Our Ref: AA/VG: 1569/05 (90746) (41832)

## **Environmental Impact Statement: Woolgoolga to Ballina Pacific Highway Upgrade**

**Part B: Identification of Issues and Associated Implications/Recommendations****B.1: Groundwater Working Paper**

## Abandoned AC watermain

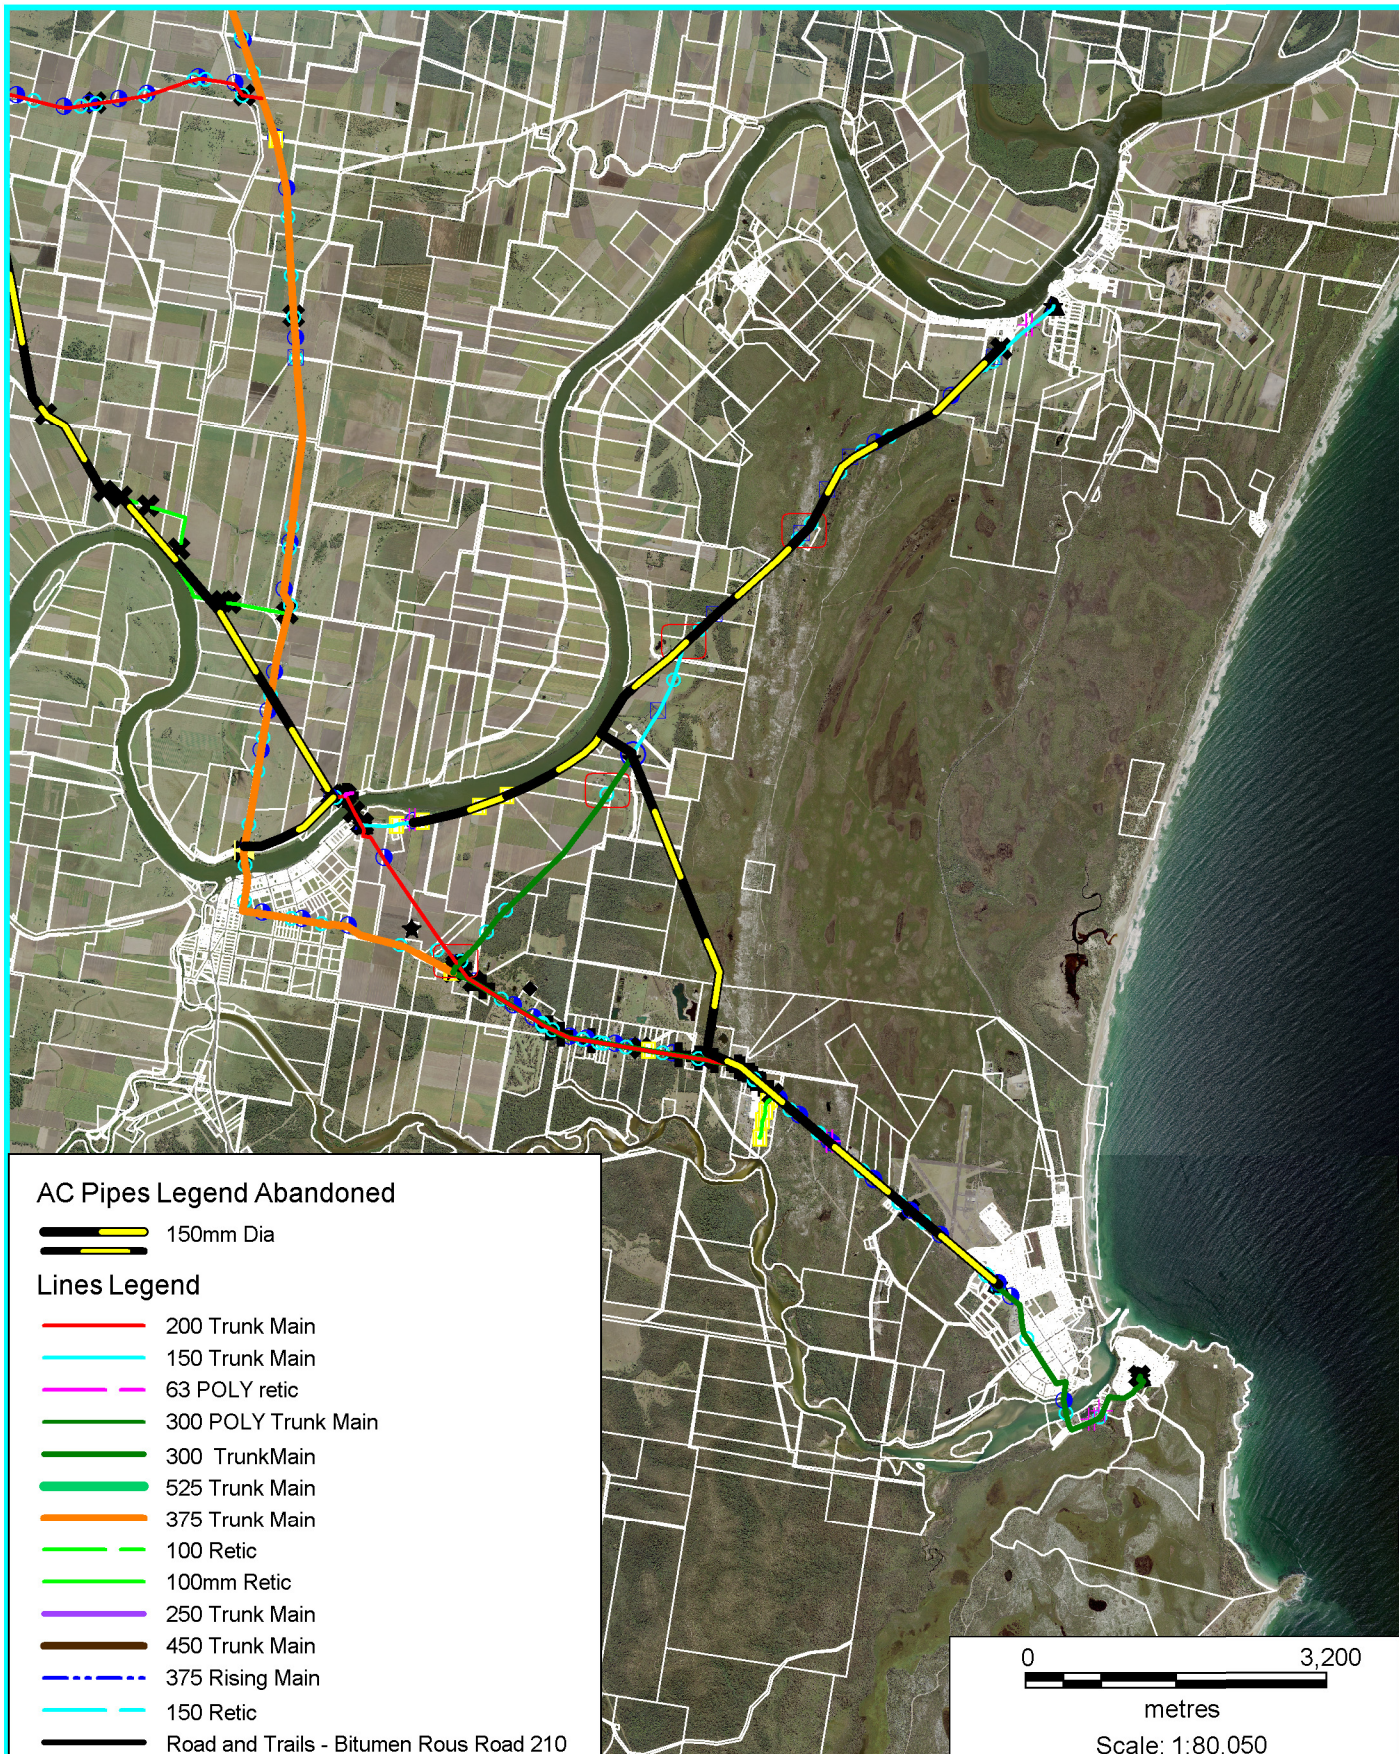
Rous Water has reviewed the works associated with the key material source area C11 and has determined that based on the current identified area, there are unlikely to be any impacts on the adjacent pipeline infrastructure. However, appropriate blasting limits may need to be applied and monitor during any blasting works. Rous Water also has a number of abandoned pipelines in and around the highway alignment, including through key material source area C11, which will require removal and appropriate disposal in consultation with Rous Water. Please find herewith the attached plans detailing the locations of these mains.
